Site Plan 8-02014

Staff Report

REVIEW TYPE: Final Water Quality Plan and Site Plan Review
APPLYING FOR: Approval of 487 dwelling units (153 SFD, 202 TH's and 132 multifamily units) inclusive of 46 MPDU's on 77.61 acres
PROJECT NAME: Clarksburg Town Center Phase II
CASE #: 8-02014
REVIEW BASIS: Sec. 59-D-3, M. C. Zoning Ordinance

Park/School
Site

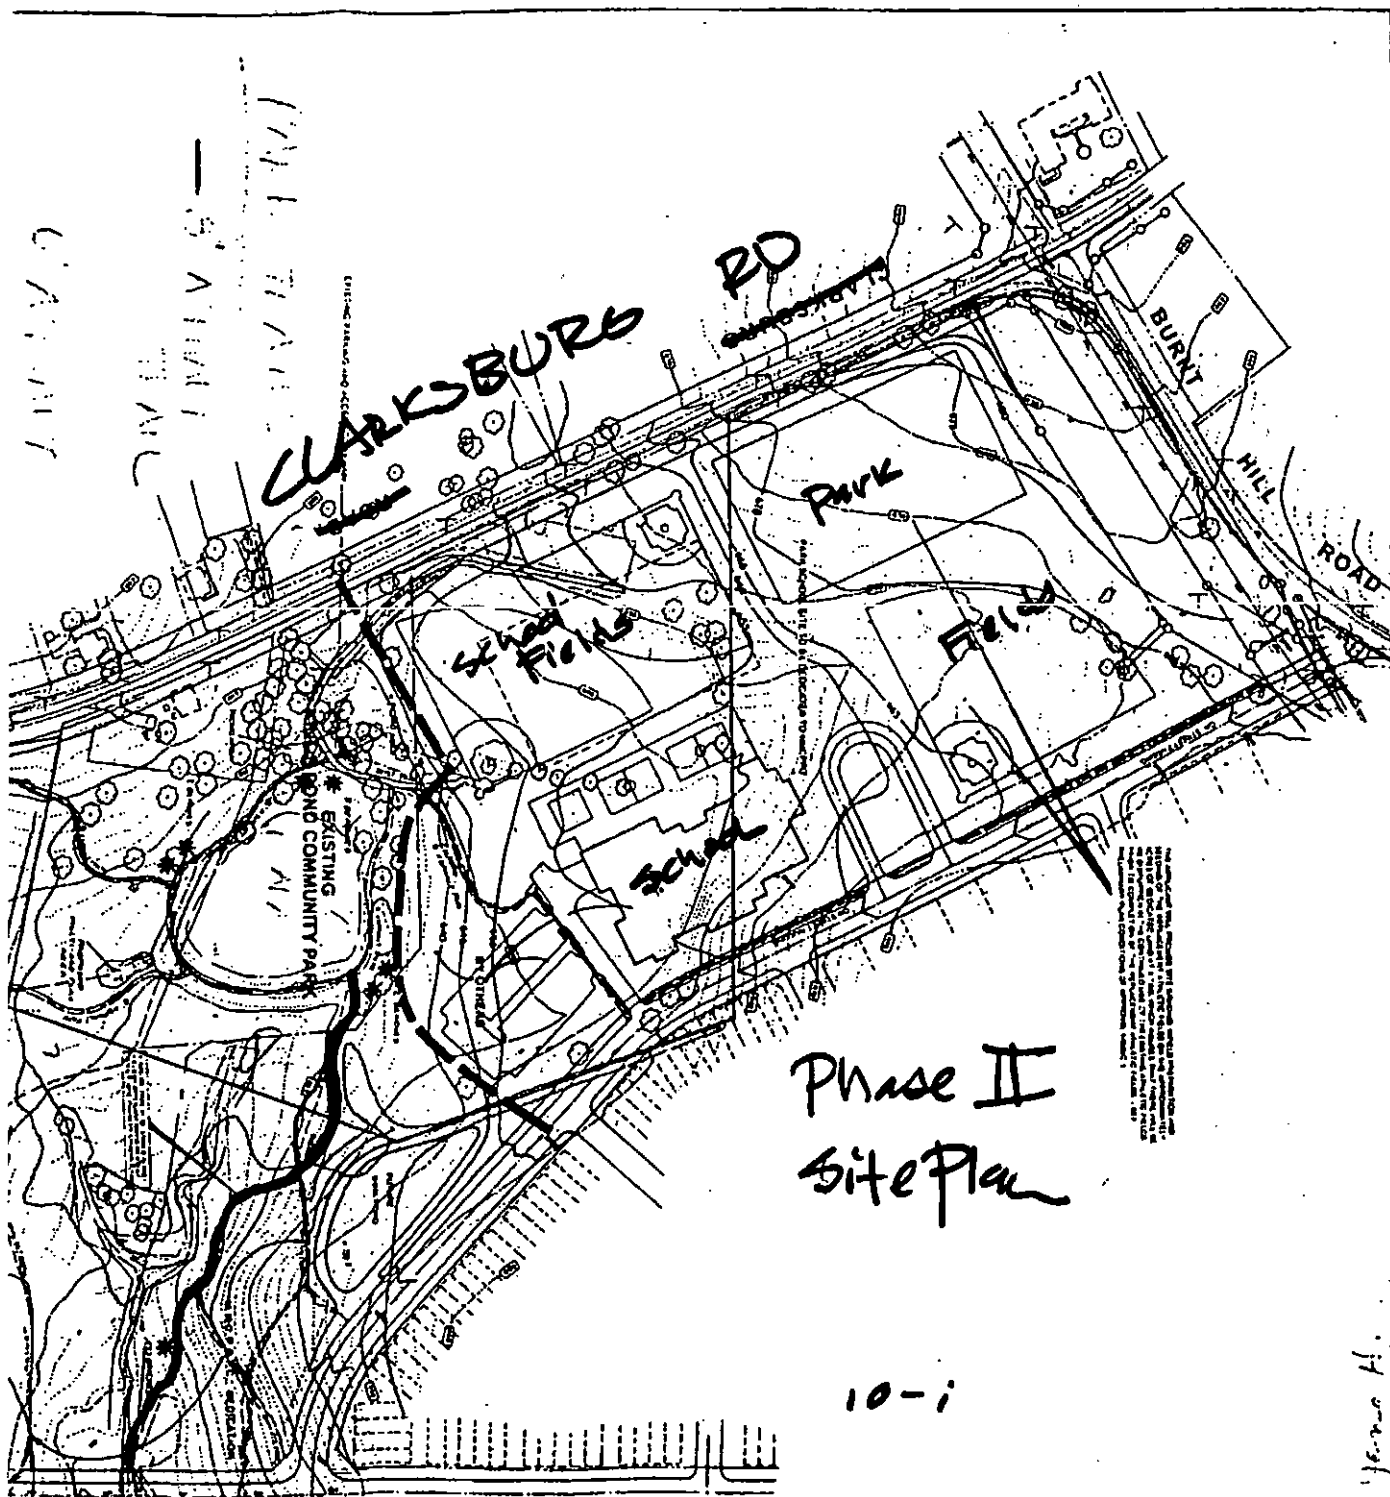
Current plans call for the construction of two ballfields that will be dedicated to the M-NCPPC. Plans call for a ten-foot grade difference between these fields and the school property, necessitating the construction of a retaining wall. Montgomery County Public Schools requests that as a condition of the site plan approval, the applicant be required to re-configure the ballfields, locating them further from the school property line, or if this is not feasible, construct an adequate retaining wall to accommodate the difference in grade.

MCPS requests that as a condition of site plan approval, the applicant provide adequate engineered fill for the building and rough grade the remainder of the school site to allow school construction at reasonable cost. Alternatively, if this cannot be done, MCPS will consider another site within the subdivision.

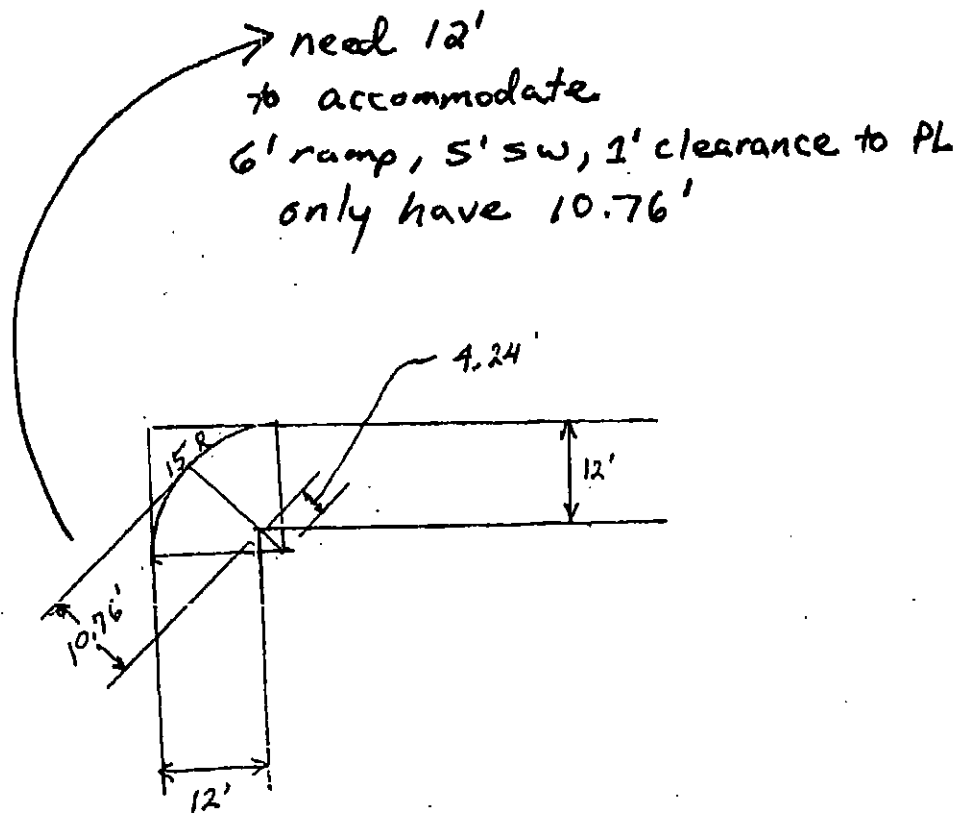
- Block N – the street block adjacent to Lots 39-42 must be private since its only egress is via an alley on the north. We recommend that a waiver be granted to allow single - family houses on a private street. The loop road around the central square should be shown as one-way counterclockwise. A horizontal curvature waiver is needed for the curve on the southwest corner of the square.

- Block M – the loop road around the square will need a horizontal curvature waiver. However, the radius on the curve on the east corner still needs to be increased. The loop road around the square should be shown to operate one-way counterclockwise.

- Grapevine Ridge Road will operate one-way northbound; this should be shown on the plan. The chokers at either end of Grapevine Ridge Road south of Clarksburg Square Road should be eliminated.

- Curb ramps at intersections must meet MCDPWT and ADA dimensions; this may require some additional right-of-way (truncation) at some intersections. The attached drawing shows that where truncations are not provided on tertiary streets, the required space to install the six foot long ramp, a five foot level sidewalk area and one foot of clearance to the property line is not available.
